To: Public Utility Commission and Staff

From: Elizabeth Graser-Lindsey  
Beavercreek, OR 97004

Date: April 27, 2023

Re: PGE CEP/IRP Report filed in Docket No. LC 80

Figure 78. Decarbonization glidepath portfolios

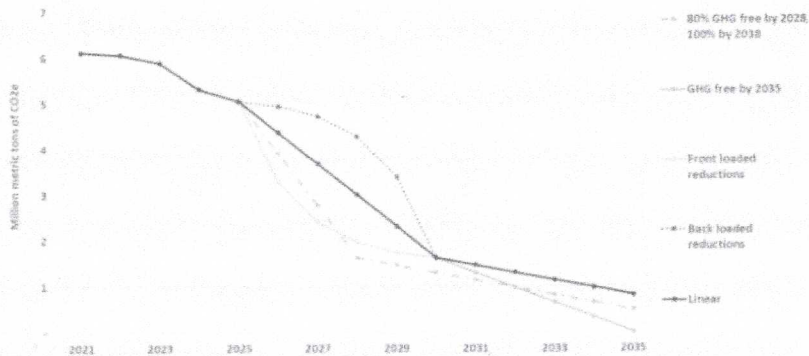
**In the interest of Oregon's low-risk and low-cost goals for electricity, PGE needs to take the front-loaded path in emission declines (the front-loaded decarbonization glide path) rather than the linear path in emissions decline (linear decarbonization glide path).**

The front-loaded emission reduction is the lightest gray between 2026 and 2030. Fig. 79 p. 262.

**Figure 82. Cost and risk of accelerated decarbonization glidepath portfolios**

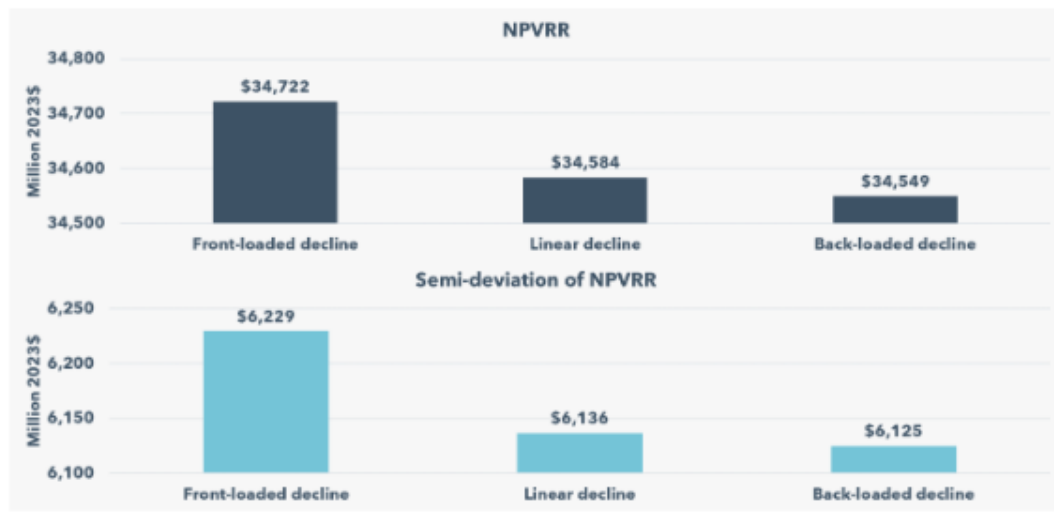
- (PGE’s NPVRR and semi-deviation of NPVRR bar graphs exaggerate the differences between the portfolios by the use of truncated bars – to show just the

tip of the bar graph – and then a stretched vertical axis on the graphs.)

The risk differential is small, so the unquantified risks, mentioned in previous bullets, are likely to exceed the unspecified, but quantified, risks. If all the risks could be quantified properly, the front-loaded option would be the more rational preferred option.
